ALERT SERVICE BULLETIN
REVISION NOTICE
Bell Helicopter **TEXTRON**
A Subsidiary of Textron Inc.

SUBJECT: **REVISION "D" TO ALERT SERVICE BULLETIN 212-00-111 (TAIL ROTOR BLADE 212-010-750-009 THROUGH -129 TIP BLOCK MODIFICATION)**

NO. 212-00-111

SUBJECT: TAIL ROTOR BLADE P/N 212-010-750-009
THROUGH -129, TIP BLOCK RETENTION
MODIFICATION

Figure 1
212-010-750-ALL
TAIL ROTOR TIP RETENTION MOD

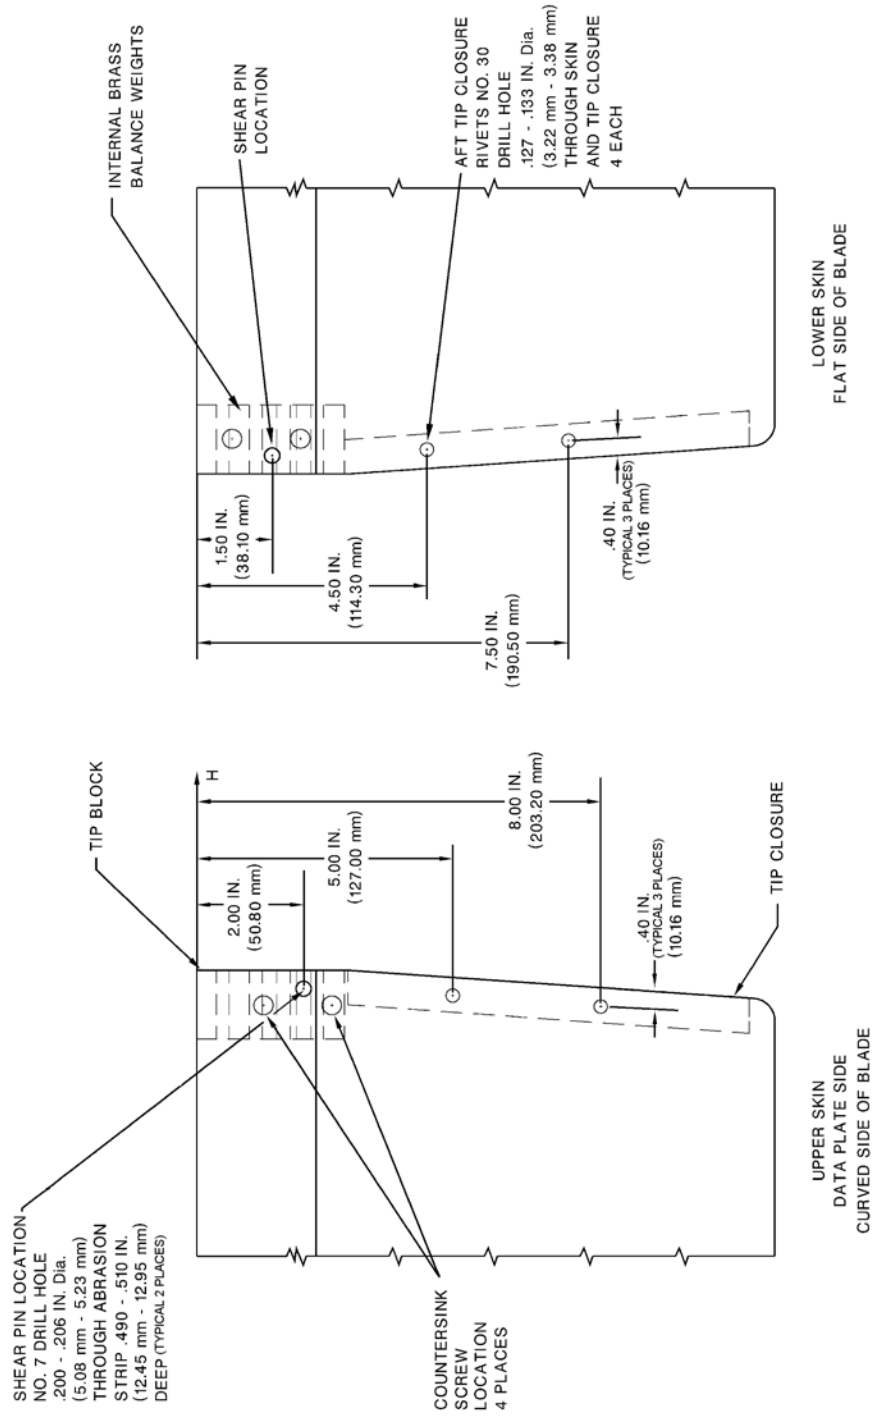
Revision "D" to this bulletin provides an alternate fastener for the tail rotor blade tip closure rivets installation.

This alternate rivet P/N NAS9307M-4-01 has a monel sleeve which is more erosion-resistant. Installation of this rivet with sealant MIL-PRF-81733 in lieu of adhesive 299-947-100 TY2 CL 2 will offer a better protection against water contamination and corrosion. An oversize rivet P/N NAS9310M-4-01 is also added to the material list.

1. Deleted
2. Inspect forward tip weight retention block and aft tip closure for voids. Remove any blade from service that exhibits voids in excess of CR&O limitations.
3. Inspect forward tip block attachment countersink screws. 4 locations. See Figure 1. Inspect to insure that the head of the countersunk screw is flush with the surface of the abrasion strip.
4. T/R blades that have the screws flush with the surface of the abrasion strip in all 4 locations do not require shear pin installation. T/R blades with one or more of the screws that are set below the surface of the abrasion strip or are covered with filler material may not provide acceptable retention of the tip block in the event of adhesive failure and will require shear pin installation. The limit is flush to 0.010 inch (0.0254 mm) high.
5. The aft tip closure rivet installation must be accomplished on all tail rotor blades.

1. Using a clean, sharp No. 7 drill bit, drill a **.50** inch deep shear pin installation hole as shown on Figure 1. The upper surface of the blade can be identified as the curved side of the blade and is same side as the data plate. Likewise the lower surface of the blade is the most flat side of the blade. The shear pin installation holes are located at 2.0 inches (projected) aft of the leading edge on the upper surface and 1.5 inches (projected) aft of the leading edge on the lower surface.

1. Using a clean, sharp no.30 drill bit, drill two rivet installation holes on both the upper and lower surface of the blade tip as shown in Figure 1. It is not necessary to remove the paint in the area.

2. De-burr drilled holes and verify rivet fit. Clean M7885/2-4-01 or NAS 9307M-4-01 rivets and drilled holes with Aliphatic Naphtha. Wipe dry before solvent evaporates.

3. Obtain a kit of sealant per MIL-PRF-81733. Thoroughly mix the accelerator, add it to the base product, then thoroughly mix the mixture until a uniform color, devoid of streaks, is achieved.

4. Coat rivet-shanks with MIL-PRF-81733 sealant and install verifying that rivet heads are seated firmly with blade skin. Allow a fillet of adhesive to squeeze out around rivet heads to insure blade is sealed.

5. Allow sealant to cure for 24 hours at room temperature. Refinish rivet heads in accordance with 212 MM for blade refinishing. Re-identify the modified blade by the addition of "FM" after the part number (i.e., 212-010-750-109FM).
